STAFF REPORT
COMMUNITY DEVELOPMENT DEPARTMENT

HEARING DATE: 09/10/2024
TO: Mayor & City Council
FROM: Nick Napoli, Associate Planner
208-884-5533
SUBJECT: Avani No. 1
FP-2024-0013
LOCATION: Southeast of Franklin Road and Black Cat, North of I-84, in the SW ¼ of the NW ¼ of Section 15, T.3N., R.1W. (Parcel #S1215233650)

Final Plat consisting of 67 single family building lots and four (4) common lots on 11.88 acres of land in the R-15 zoning district for the first phase of Avani Subdivision.

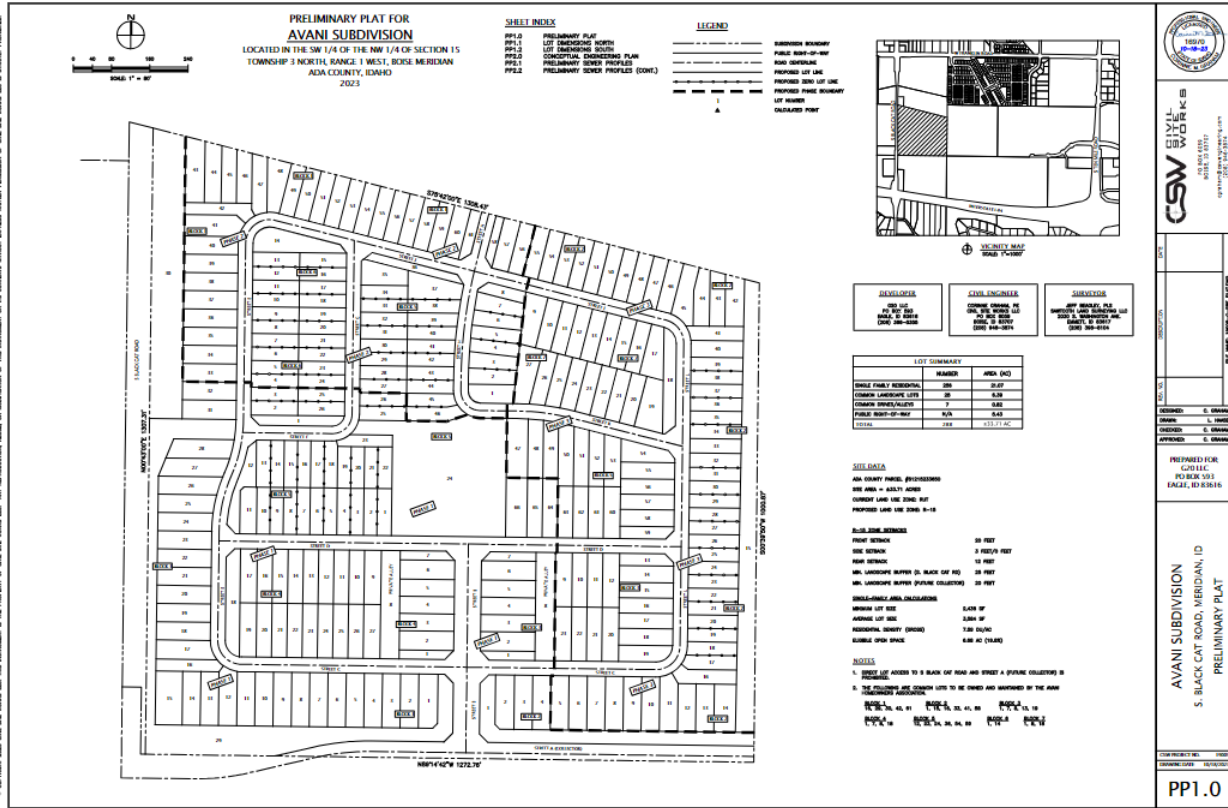
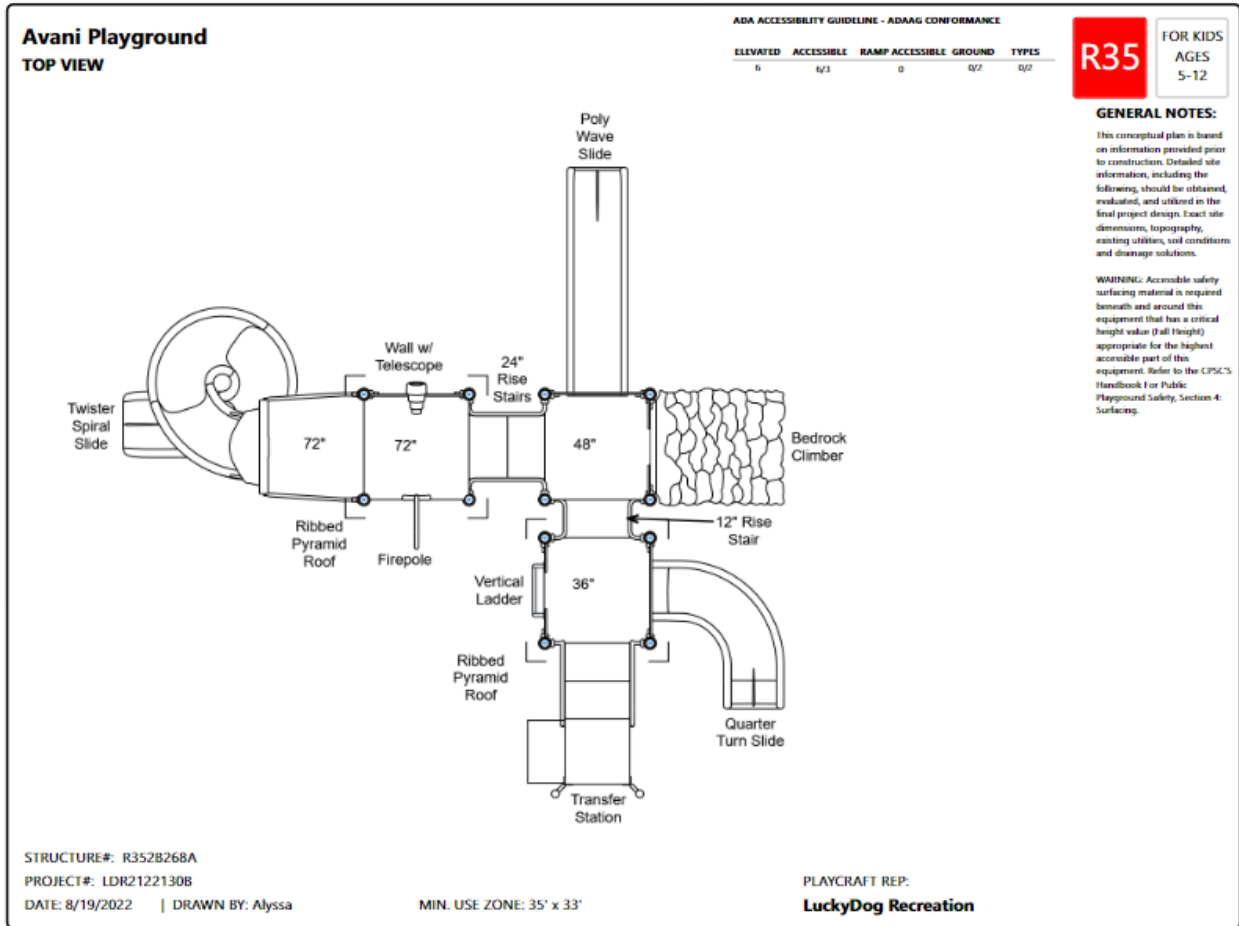
Staff has reviewed the proposed final plat for substantial compliance with the approved preliminary plat ([H-2023-0031](#)) in accord with the requirements listed in UDC 11-6B-3C.2.

In order for the proposed final plat to be deemed in substantial compliance with the approved preliminary plat as set forth in UDC 11-6B-3C.2, the number of buildable lots cannot increase and the amount of common area cannot decrease. Since there is no change to the number of buildable lots and the amount of common open space is the same, therefore, Staff deems the proposed final plat to be in substantial compliance with the approved preliminary plat as required.
